# SAN FRANCISCO PLANNING DEPARTMENT

DATE: November 15, 2013  
TO: Orrin Goldsby  
FROM: Nannie Turrell, Planning Department  
RE: PPA Case No. 2013.1339U for 645-647 Valencia Street

## Preliminary Project Assessment

*Date:* November 15, 2013  
*Case No.:* **2013.1339U**  
*Project Address:* 645-647 Valencia Street  
*Block/Lot:* 3576/062  
*Zoning:* Valencia St Neighborhood Commercial Transit (Valencia Street NCT)  
Mission Alcohol Beverage Special Use Subdistrict  
Fringe Financial Service Restricted Use District  
55-X Height and Bulk District  
*Area Plan:* Mission  
*Project Sponsor:* Orrin Goldsby, Kerman/Morris Architects LLP  
415-749-0302  
*Staff Contact:* Tania Sheyner – 415-575-9127  
[Tania.Sheyner@sfgov.org](mailto:Tania.Sheyner@sfgov.org)

Title: 645-647 Valencia St Preliminary Shadow Analysis

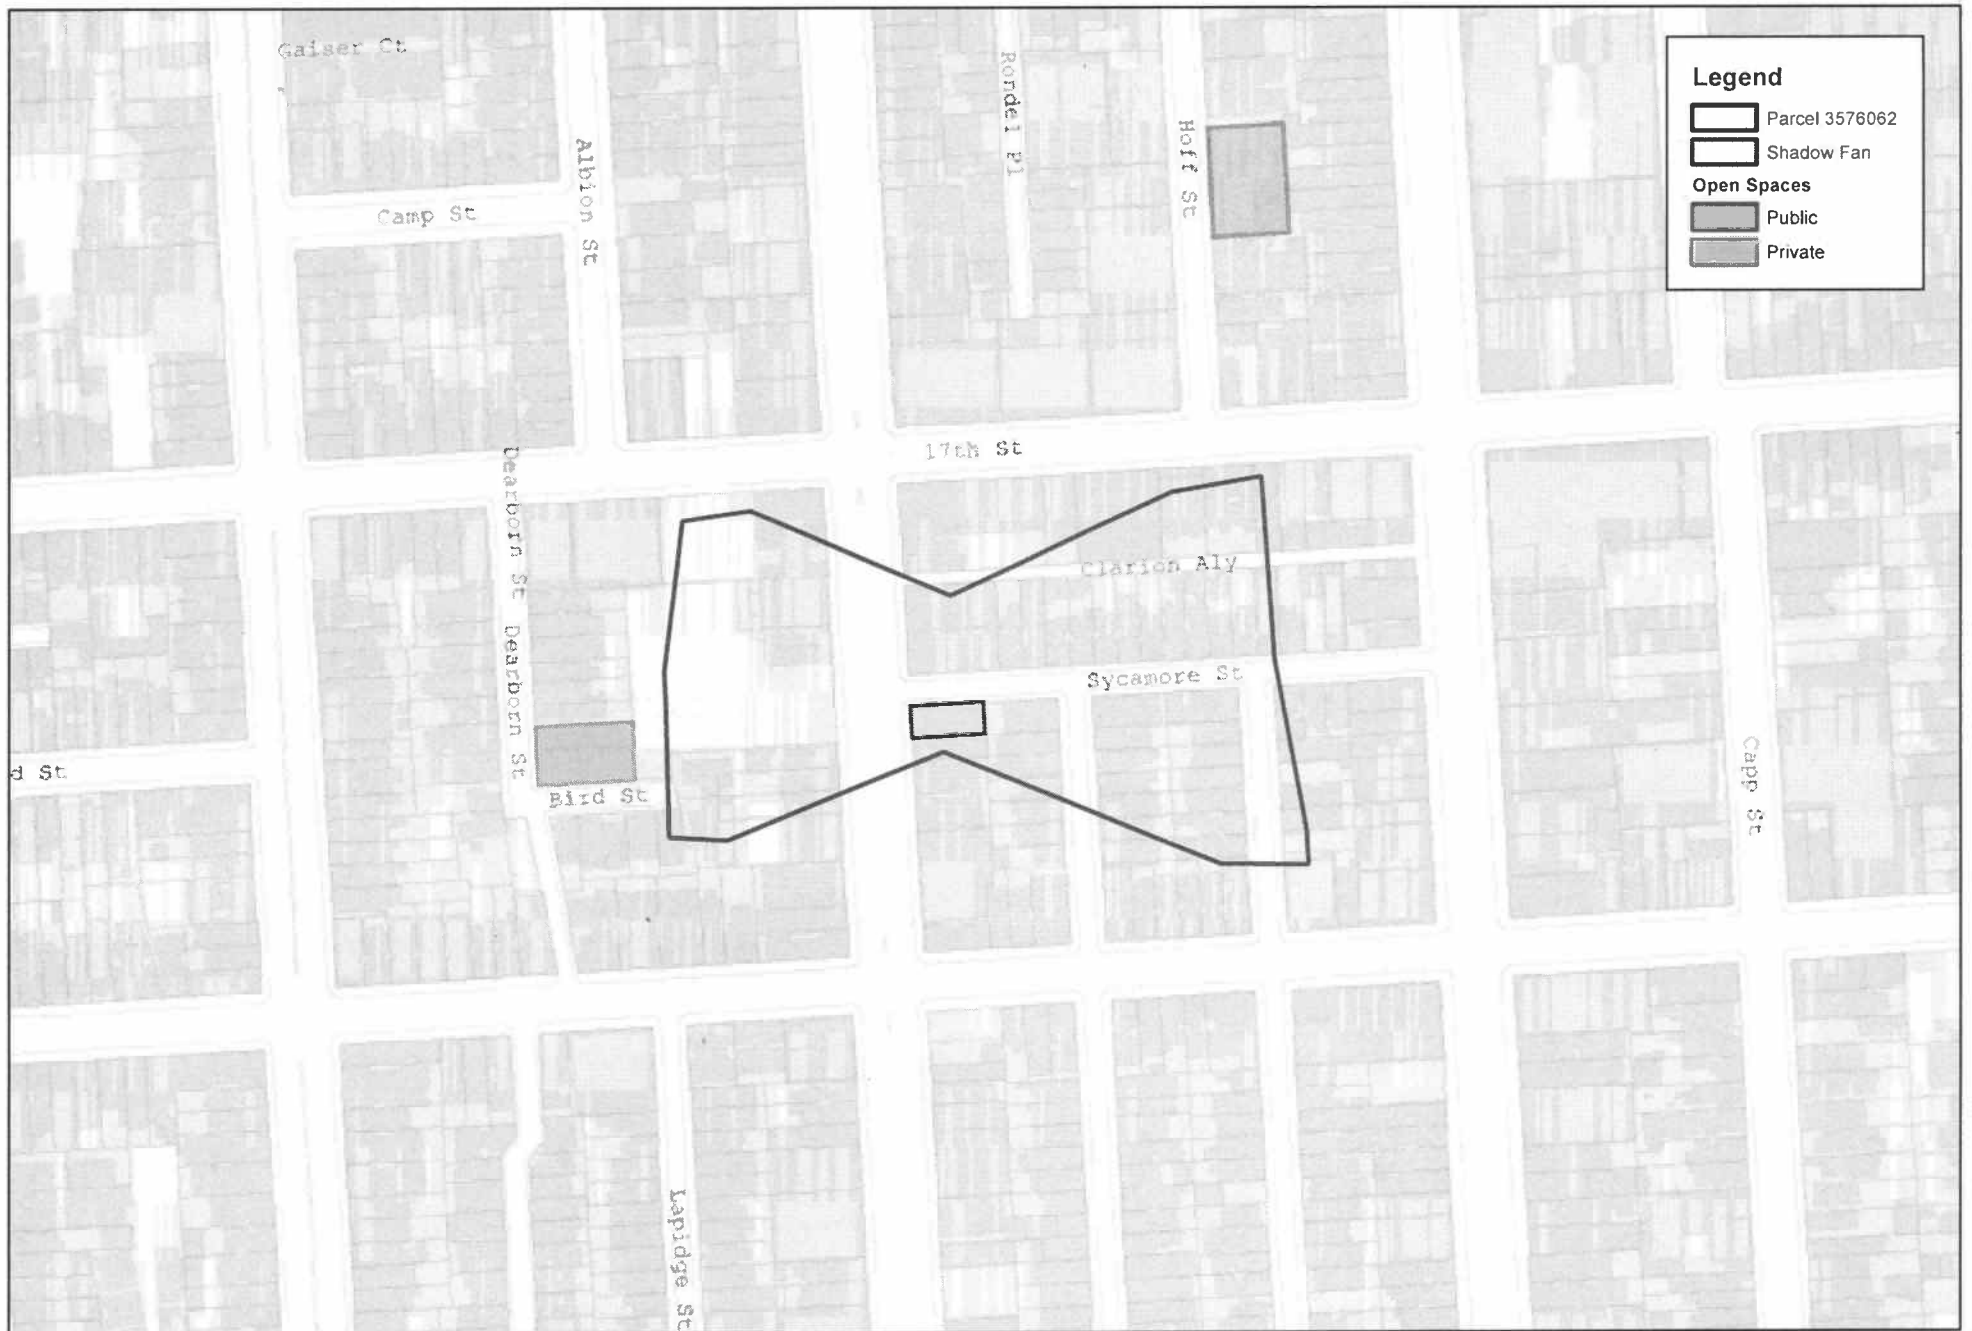
whether a project has the potential to cast shadow on properties under the jurisdiction of the San Francisco Recreation and Park Commission. Department staff has prepared a shadow fan that indicates the project would not cast new shadow on any properties under the jurisdiction of the Recreation and Park Department, nor would it cast shadows on any other parks or open spaces (see attached).

12. **Shadow:** Planning Code Section 295 outlines requirements for projects with a height exceeding 40 ft that cast shadows on property under the jurisdiction of the Recreation and Parks Commission. As discussed above, under Environmental Review, based upon an initial shadow study, the proposed project would not impact any properties subject to Planning Code Section 295.
